Urgent: Field Safety Notification FSN20149997

Follow-up action for the Application Instrument of Sternal ZipFix™: Changes in the Surgical Technique Guide

| Part Description | Part Numbers | Lot numbers |
|--|--------------|---|
| Application Instrument for Sternal ZipFix™ | 03.501.080 | All 1st generation Application Instruments (Lots prior to 8100630) |

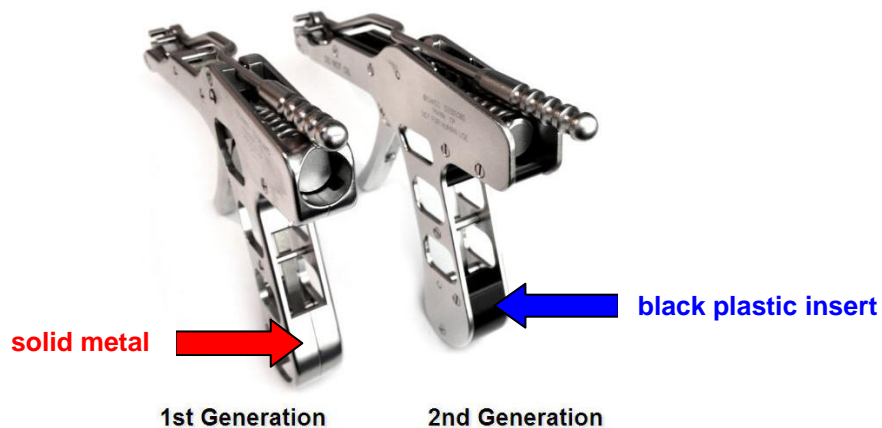
NOTE: This issue applies to the 1st generation Application Instrument only. The 1st generation instrument is distinguishable by the presence of an all stainless steel handle. Please see the figures below for 1st generation and 2nd generation instruments.

Table 1: Updated version of the Surgical Technique Guide (036.000.285 AE) gives precise instructions how to avoid cutting the implant while tensioning with the application instrument .

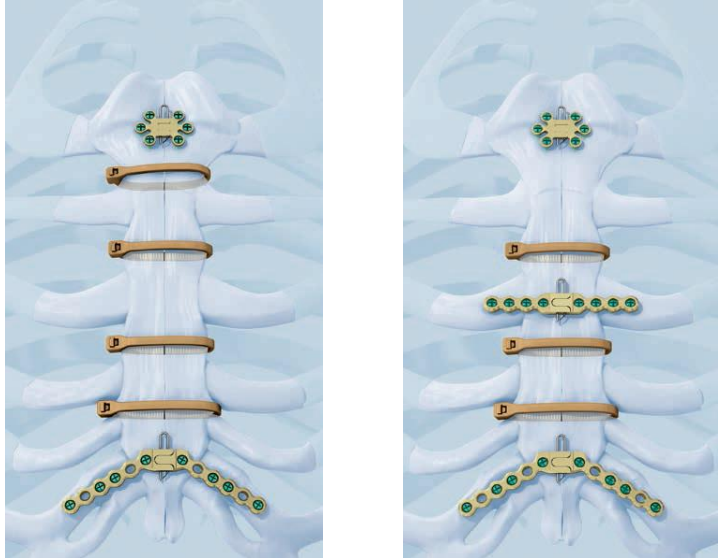
| Table 1 Updated Surgical Technique Guide on Sternal ZipFix™ | | | |
|--|------|--|------|
| Part: Surgical Technique Chapter: Surgical Technique Section: 7 Remove excess material This chapter is newly constructed to ensure how to avoid cutting under tension. Newly added wording: “Warning: The tensioning trigger must be completely released before and during implant cutting. Cutting the implant while tensioning with the application instrument could compromise the implant lock and lead to implant failure. Do not cut the implant under tension. ...The excess material can also be removed with a wire/pin cutter.” | 14 | “Ensure the cutting lever is in the locked position. Precaution: The trigger must be released before and during cutting. Do not cut under tension.” | 14 |
| New: Detailed images show the position of the cutting lever locked and unlocked. An arrow indicates “Locked position” .  | 14 | | 14 |

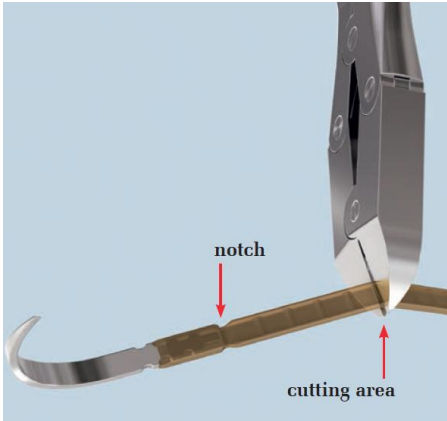
| Table 1 | | | |
|---|----|---|-------|
| Chapter: Surgical technique Section: 5 Secure Sternal ZIPFIX implants New: “Repeat for the remaining ZIPFIX. Remove forceps, if used.” In order to emphasize that it must not be cut under tension the following text has been added: “Prior to insertion of the cut end, ensure the ZIPFIX is properly oriented such that the toothed surface contacts the sternum. Avoid excessive force when tightening implant. Do not use forceps to tighten implant. Damage resulting from excessive force or forceps may cause implant failure.” | 12 | “Stainless steel needles must be removed before closing the Sternal ZipFix implants to avoid damage to the locking head.” | 11 |
| Chapter: Surgical technique Section: 6 Tension Sternal ZIPFIX implants New: Detailed advice is given on the relation between tension and cutting: “The cutting lever is locked when the lever is snapped into the latch. Insert the cut end of the implant into the front portion of the application instrument and slide the application instrument down to the locking head. If required, the ZIPFIX can be tensioned again to achieve the desired stability. Warning: Do not cut the implant until all implants have been fully tensioned. Implants cannot be tensioned once cut. Do not cut implants under tension.” | 13 | “Slide the application instrument over the loose end of the implant, down to the locking head. Squeeze the trigger to tension the implant. The implant should fit snugly to the bone.” | 12-13 |

| Table 1 Updated Surgical Technique Guide on Sternal ZipFix™ | | | |
|--|----|--|----|
| <p>New: Overview illustrations provide orientation of the correct positioning of the cutting lever.</p>  | 13 | <p>Comment: The former image didn't present the cutting lever in full size, this has been changed in the updated version in order to give optimized orientation.</p> | 12 |
